Traffic Review of MP 10_0231 - Concept Plan for Australian Catholic University, Strathfield Campus

December 2012

**Department of Planning and
Infrastructure**

Figure 4.1 Approximate boundary of University-related parking

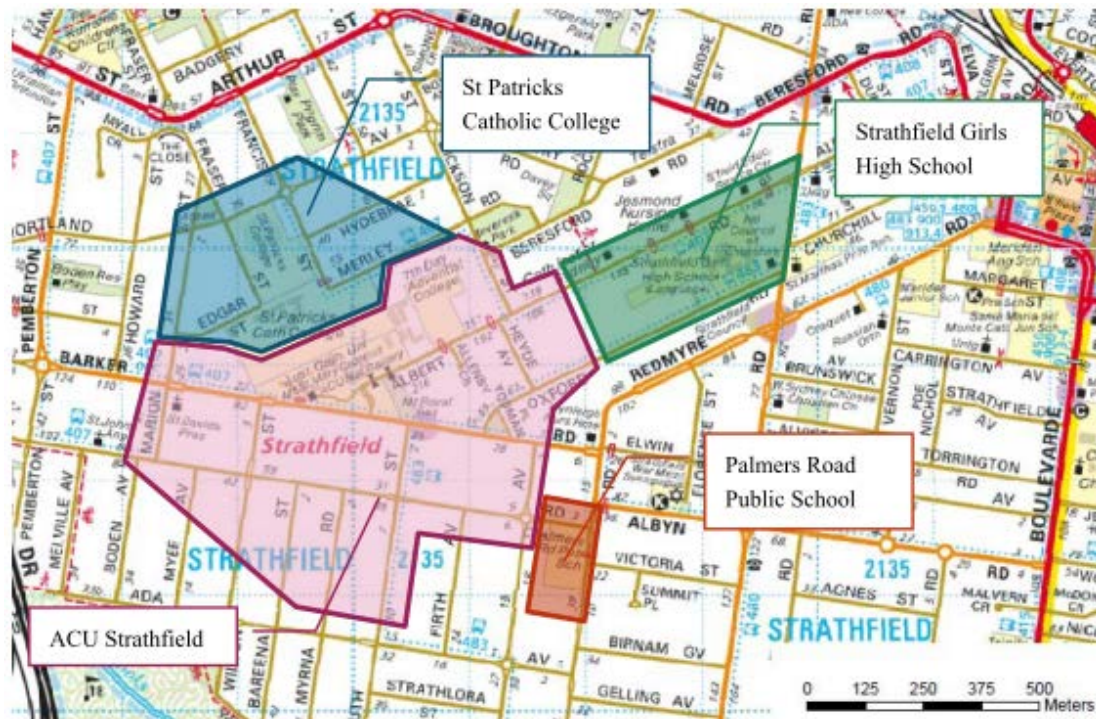
The surveys confirmed the on-street parking area diagram shown in Figure 3 of ARUP's PPR and reproduced in Figure 4.1. Parking to the north, on streets such as Merley Street, Francis Street, Fraser Street, Edgar Street and Marion Street north of Edgar Street was actually lower when University was in session. On-street parking in this area may be attributable to St Patricks College.

The number of vehicles surveyed, roughly in the pink shaded area of Figure 4.1, was:

The ARUP March 2012 parking surveys and Parsons Brinckerhoff observations indicate a relatively consistent parking impact between the start of the first and second semesters. This is contradictory to the explanation given for the decline in bus patronage (see section 3.6.1) which indicates lower student numbers in Semester 2. ARUP parking observations on Tuesday 7 August 2012 indicate a 30% reduction from the March 2012 levels. However, these observations are at odds with Parsons Brinckerhoff's observations one week earlier.

2. An on-street parking survey be undertaken outside University sessions and at the same peak student attendance time (as identified for the shuttle bus surveys) within the area identified for ACU Strathfield parking in Figure 3 of ARUP's PPR report, with the addition of streets around Inveresk Park.
